CITY OF PORTLAND, MAINE

Project Name: Amendment to July 2016 approval
“Station 415” Subdivision and Change of Use/Renovation of Building:
Co-Working Office Unit and four (4) Apartments
Project ID: #2016-196
Address: 415 Cumberland Avenue CBL: 036 G033001
Applicant: Andrew Kraus, M & A Lowcountry Investments, LLC
Planner: Jean Fraser

PLANNING BOARD REPORT PORTLAND, MAINE

SUBDIVISION AND CHANGE OF USE/ RENOVATION OF BUILDING TO CO-WORKING OFFICES AND FOUR APARTMENTS AMENDMENT TO JULY 2016 APPROVAL

Proposed Site Plan

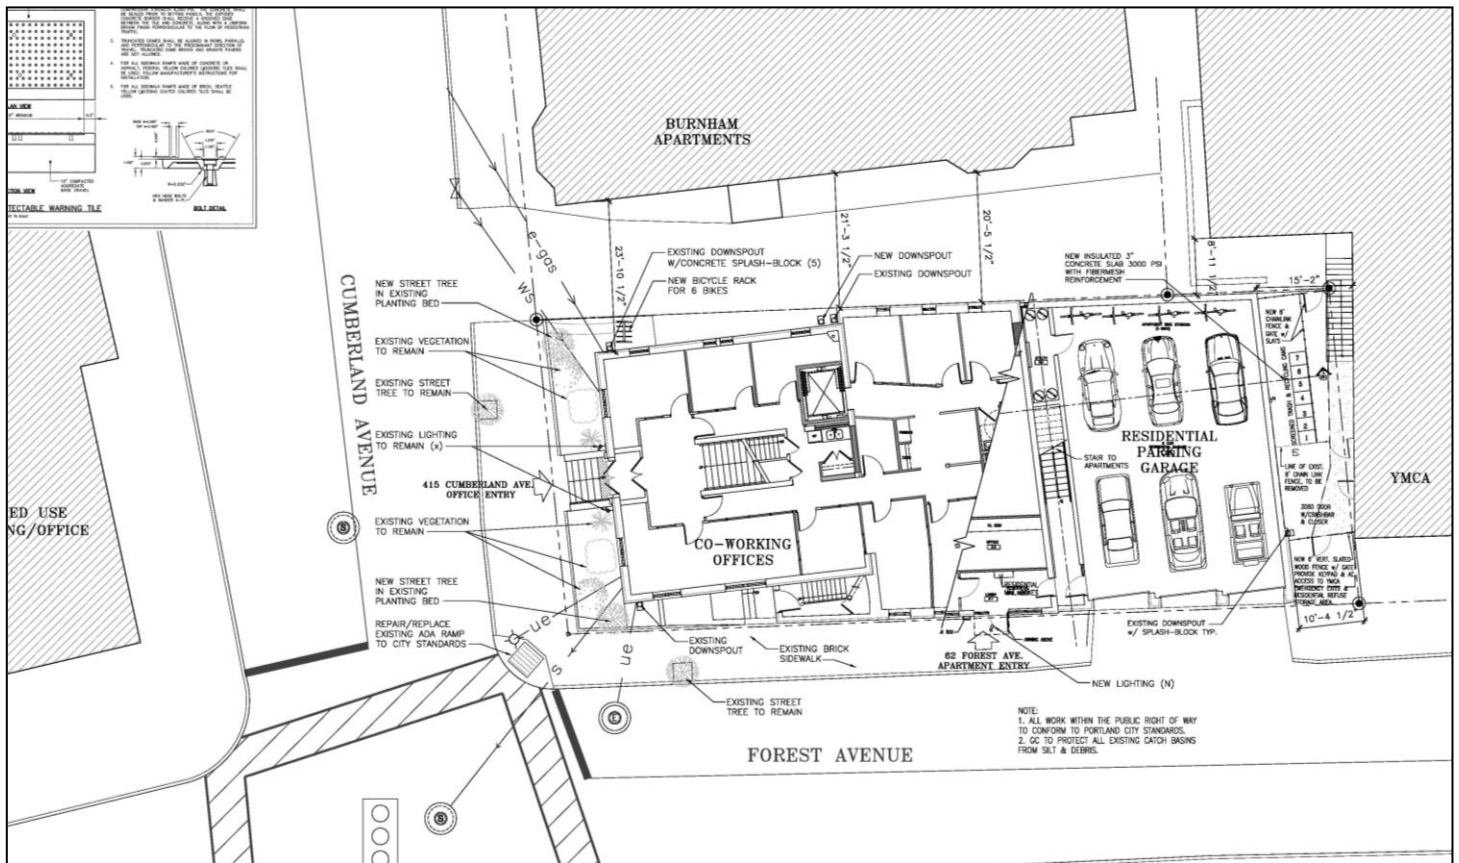
STAFF COMMENT: The proposed project is not anticipated to have any significant adverse effect on regional traffic, and the parking needs have been addressed by the retention of the 6 existing parking spaces (shown on Plan P3 as “Residential”) in the garage which have an existing curb cut that is satisfactory. The Traffic Engineering reviewer Tom Errico has confirmed in Attachment 3 that the previous comments still apply; they were:

I have reviewed the project application materials and I find conditions to be acceptable. I would suggest a condition of approval that notes the parking tandem parking spaces be designated for the residential units only (or for low turnover use). Backing maneuvers onto Forest Avenue should be minimized given vehicle and pedestrian traffic levels.

Bicycle parking totaling spaces for 14 bikes has been provided for both occupants and visitors (see Plan P3) and exceeds the ordinance requirement of 4 spaces. However, access to the 6 spaces outside is over property outside the site, so a suggested condition of approval requests that the bike parking be accessible over the applicant’s property.

A suggested condition of approval reflects these comments.

Proposed Elevation facing Forest Ave.

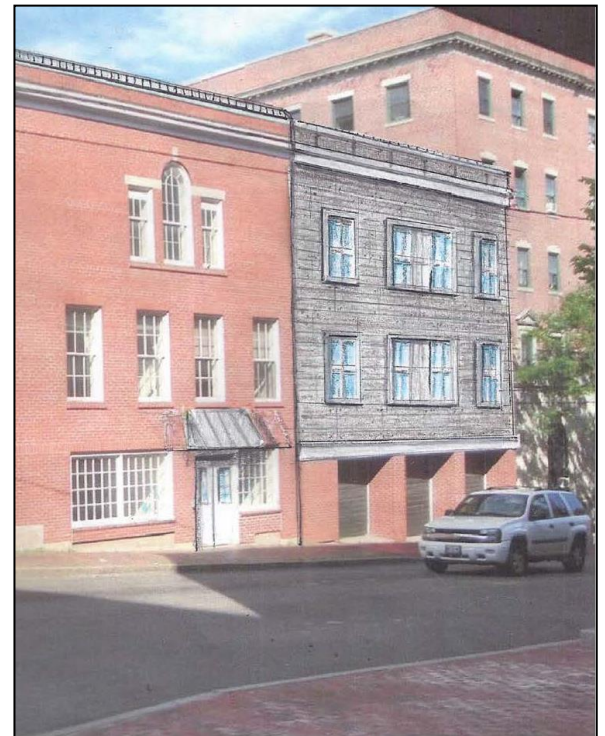
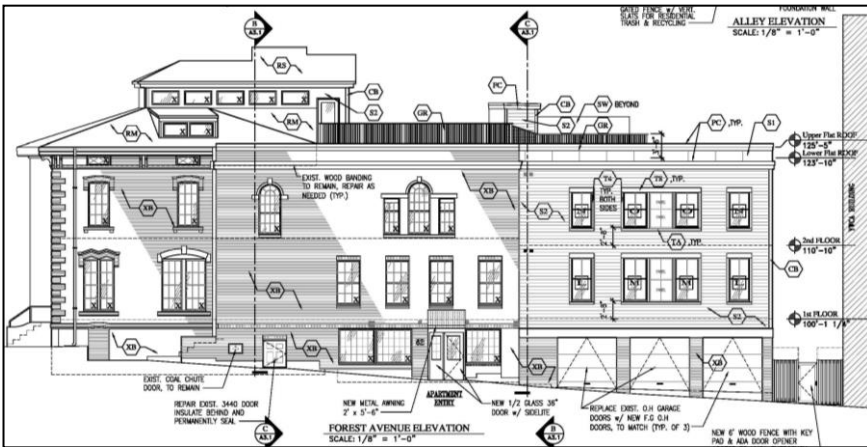
The applicant has revised the cladding since the July approval and discussed the amendment with the Historic Preservation Program Manager, Deb Andrews. A comparison between the approved and amended cladding is set out below:

The previously approved cladding was 48" X32" "Hardie" reveal panel system with aluminum trim over "Tyvar" building wrap, with aluminum fry reglets:

The current amended proposals (below) were revised to because of the high cost of the original specification. The proposed cladding is now 6" TTW "Hardie Plank" lap siding over "Tyvar" building wrap (color TBD) and illustrated below:

The Historic Preservation Program Manager, Deb Andrews, welcomes the removal of the brown wood cladding and has reviewed the amended proposals. She has confirmed that the final proposals are generally compatible with the historic structure/district (Attachment 5).

The applicant will clarify regarding the proposed color (and circulate a sample of the material) at the Hearing.
